Re: *Sunset Lofts, Traffic Engineering Comments (12/16/21)*

Lee Engineering prepared a traffic impact study, dated December 2021, for a residential development on Sunset Drive in Sedona, Arizona. As part of the City review process, a single comment associated with the report was identified (Engineering Comment #1, attached). Opposed to producing a revised report, this letter addresses the comment.

**PZ21-00018 (DEV)
Sunset Lofts (comprehensive)
12/16/21**

SEDONA LOFTS

Existing N/S Lane Configuration and Intersection Pavement Markings

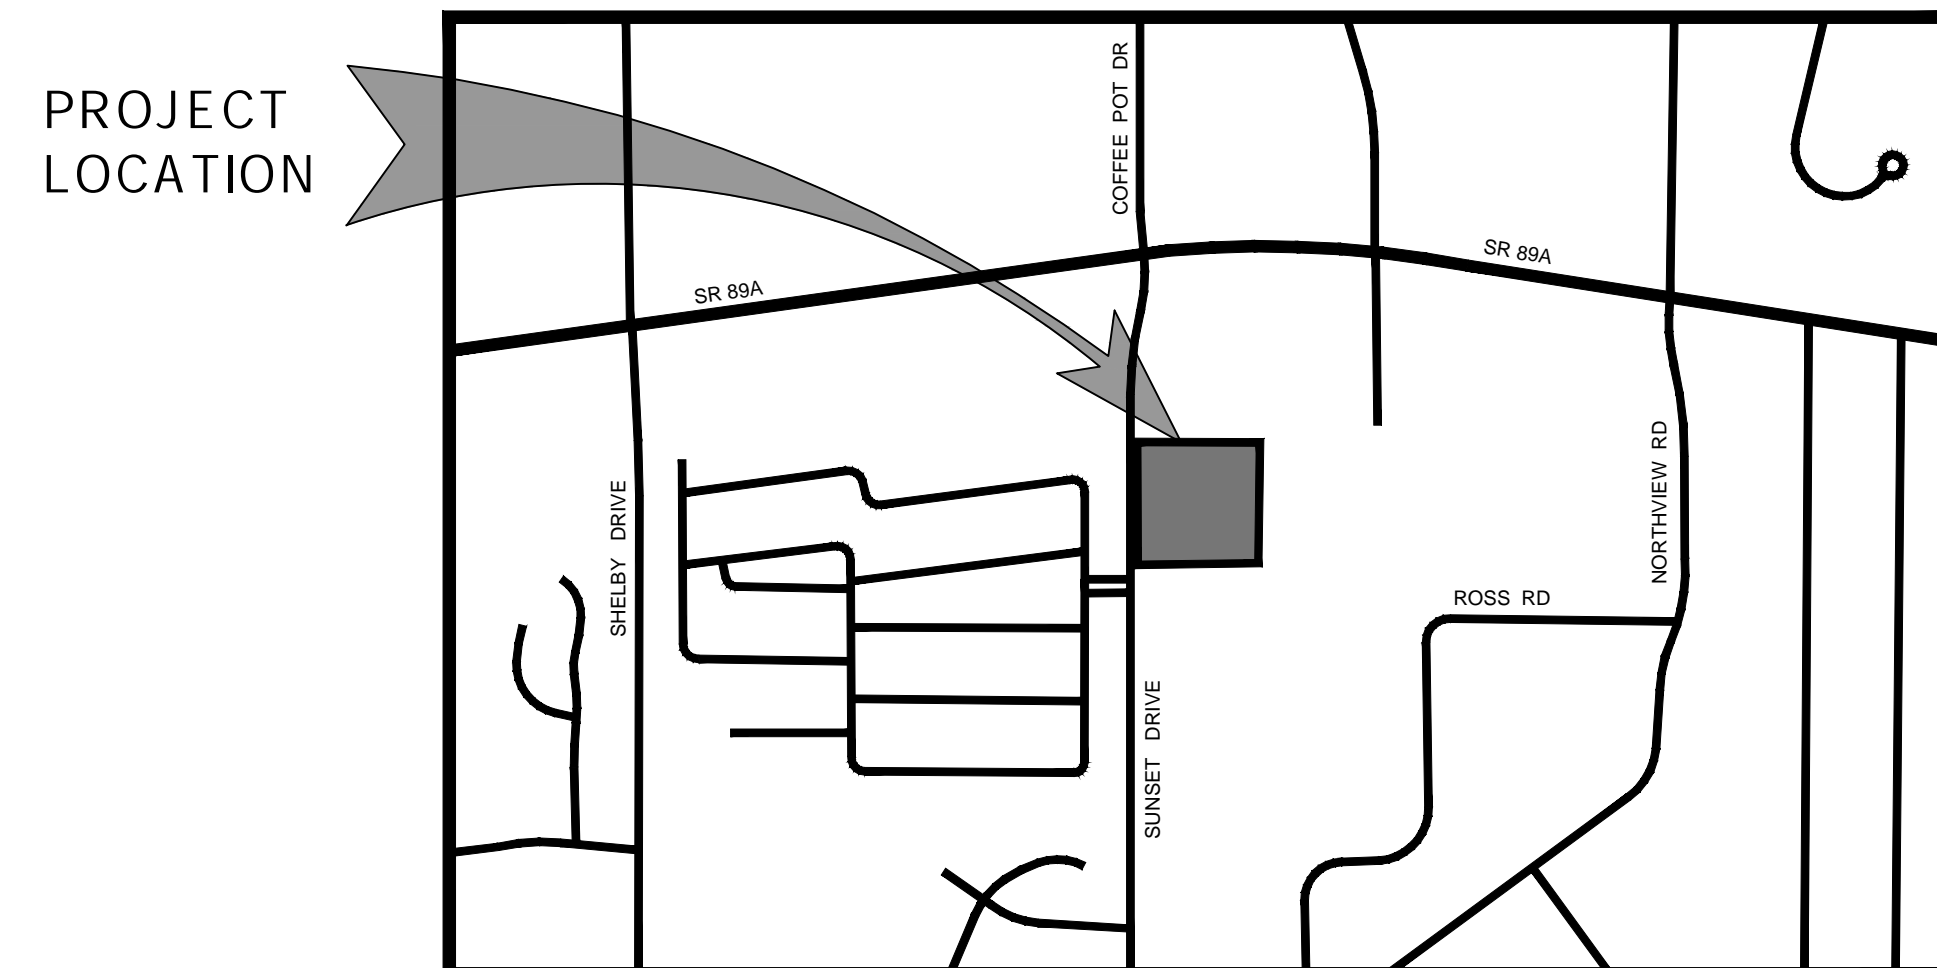
The report suggested a potential improvement to the SR 89A/Sunset Drive/Coffee Pot Drive intersection to modify the northbound middle lane from a through lane to a shared through/left lane configuration, but did not indicate the LOS impacts associated with this modification. Table 1 shows the requested LOS summary comparison of the two conditions, the top half under existing intersection conditions and the bottom half with the modified northbound approach. In review of the results, similar delays are anticipated for the northbound movements, but with the left turn and through movement queue combined and equally distributed across the two lanes, reducing the back of queue length from approximately 195 feet to 155 feet. Because the northbound phase is expected to "gap out" sooner, additional green time to the higher volume east/west approaches can be provided, slightly improving conditions for these movements and the overall operation of the intersection. The Synchro output sheets for the modified intersection design is attached while the existing condition output sheets are included as part of the original report.

If the northbound approach lane configuration is to be changed, the N/S pavement markings for the left-turn movements will also require modification, as shown in the attached graphic. Potentially, the east and west crosswalk and stop lines may need to be shifted outward.

Potential New N/S Lane Configuration and Intersection Pavement Markings

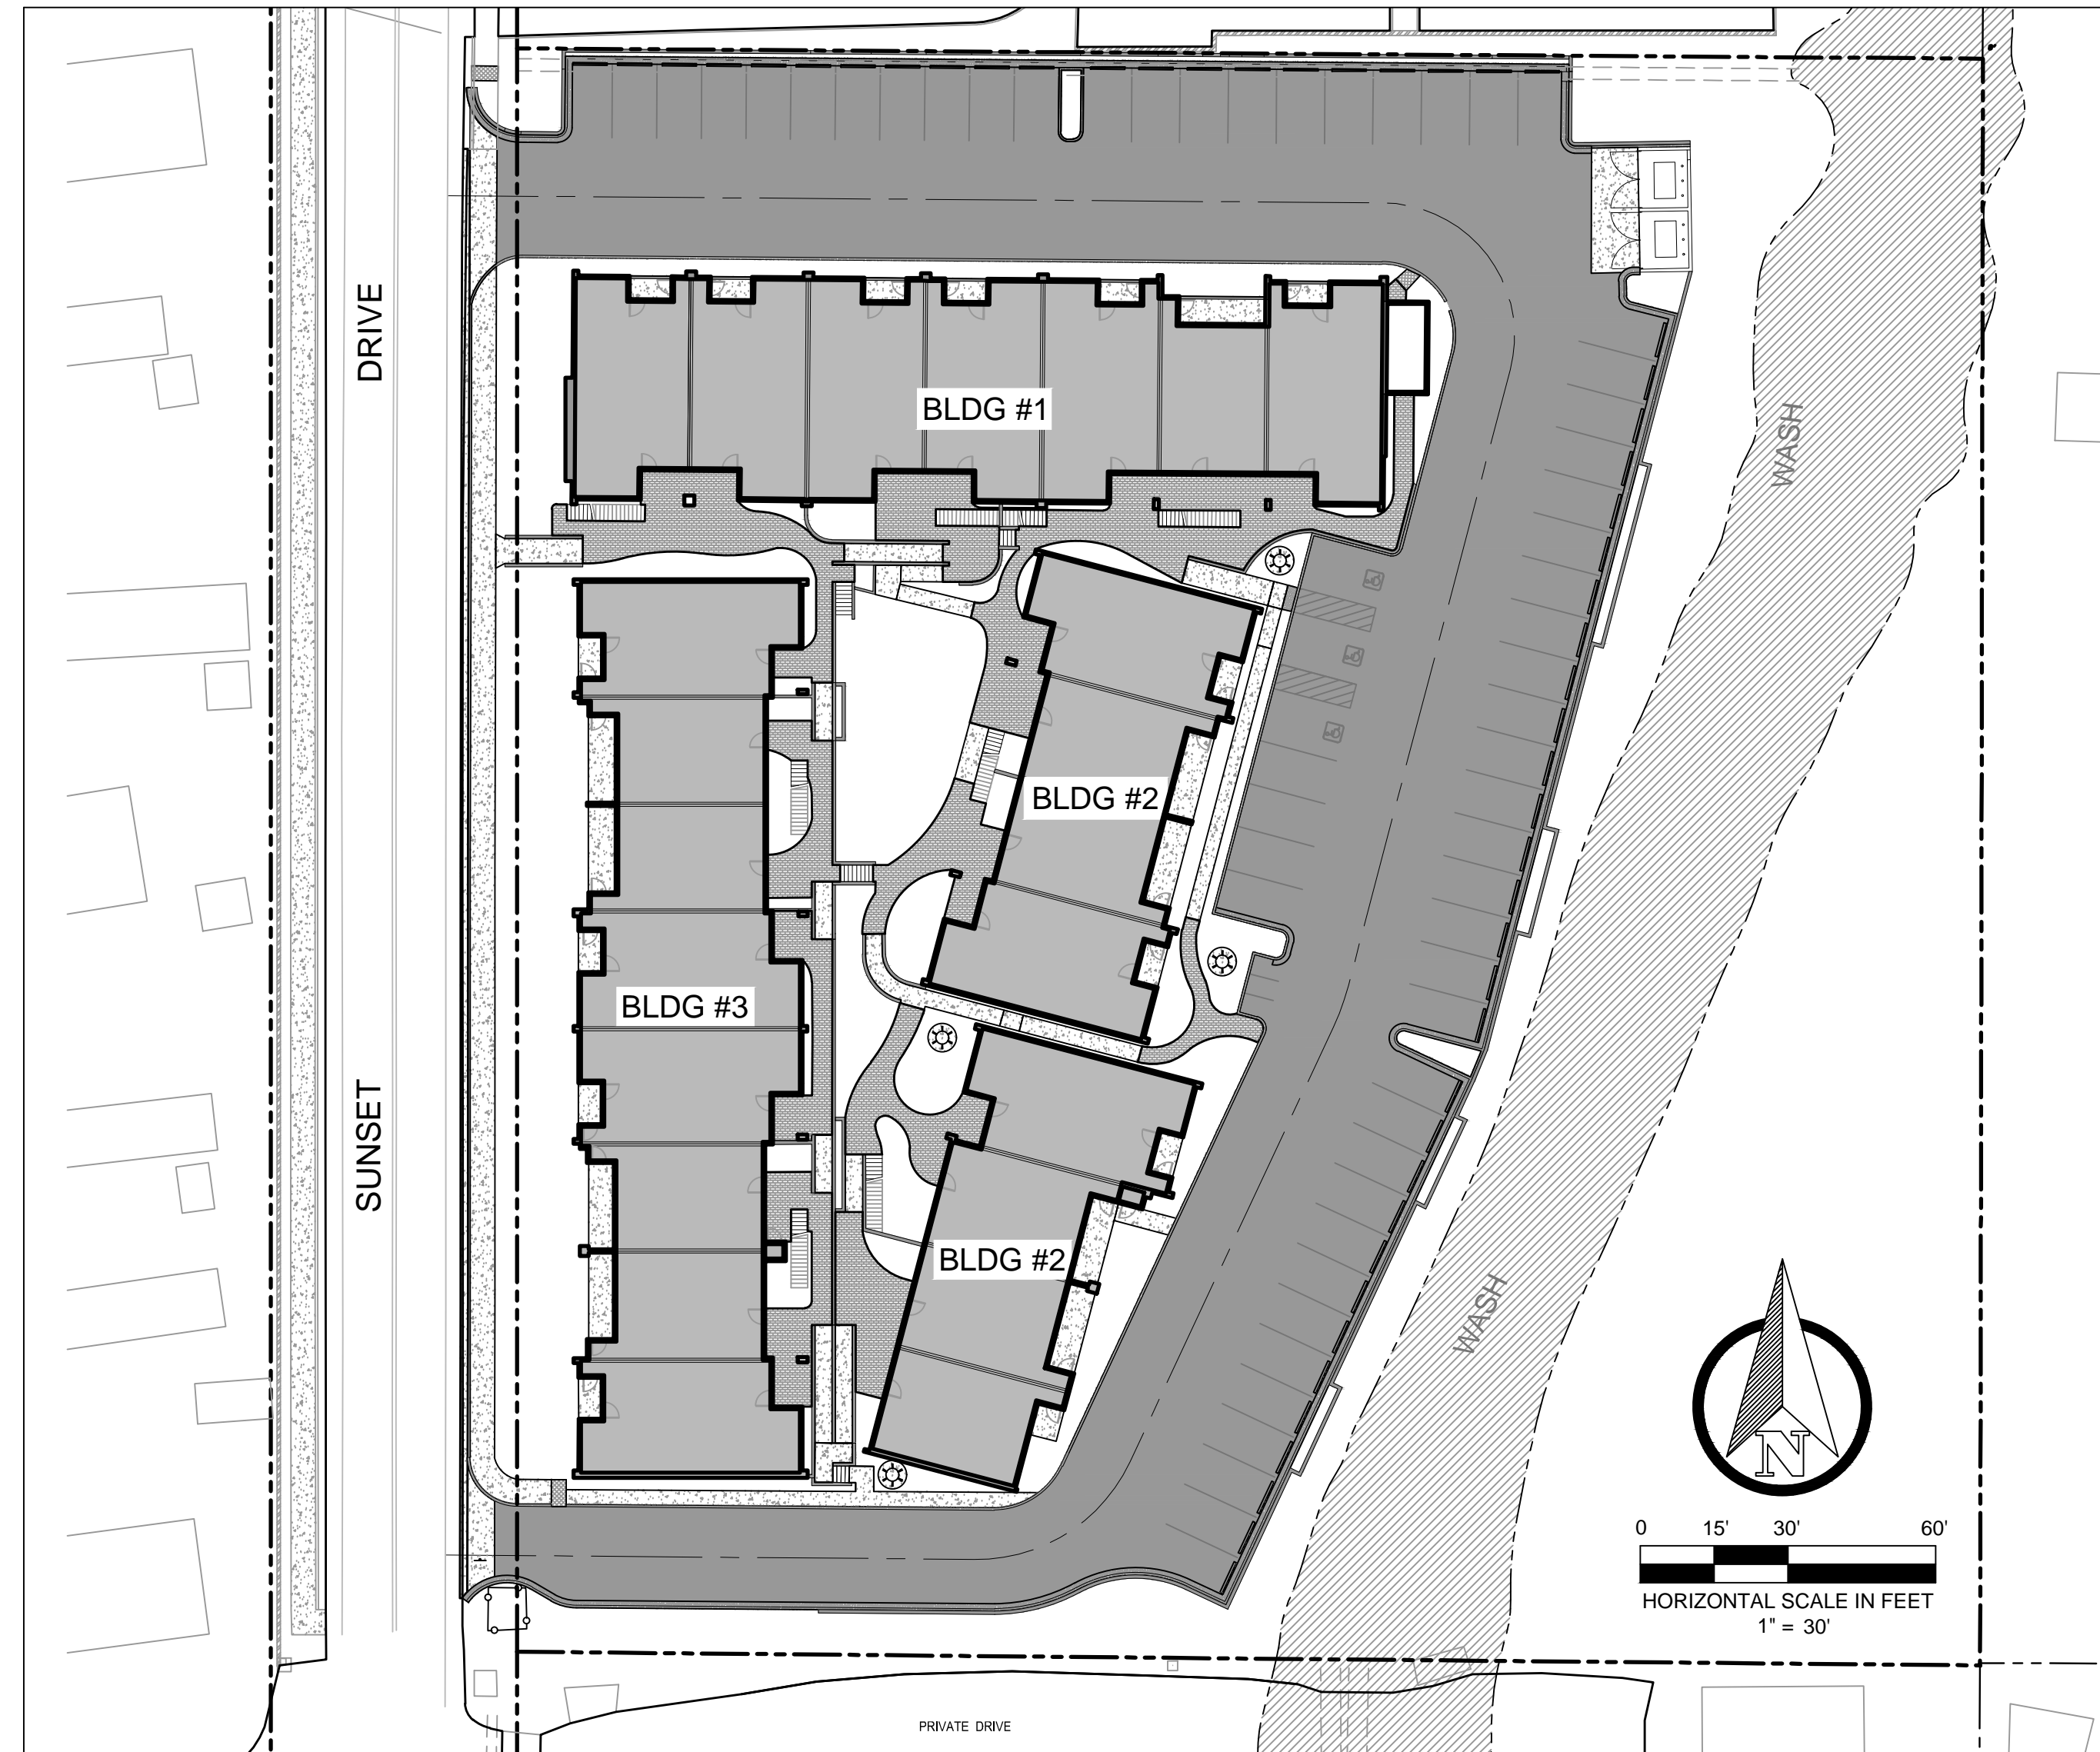
1. In the traffic impact analysis, show the effect on LOS at 89A if, as suggested, a 2nd left turn/through lane was added.
2. Stormwater storage cannot be placed in the floodway.
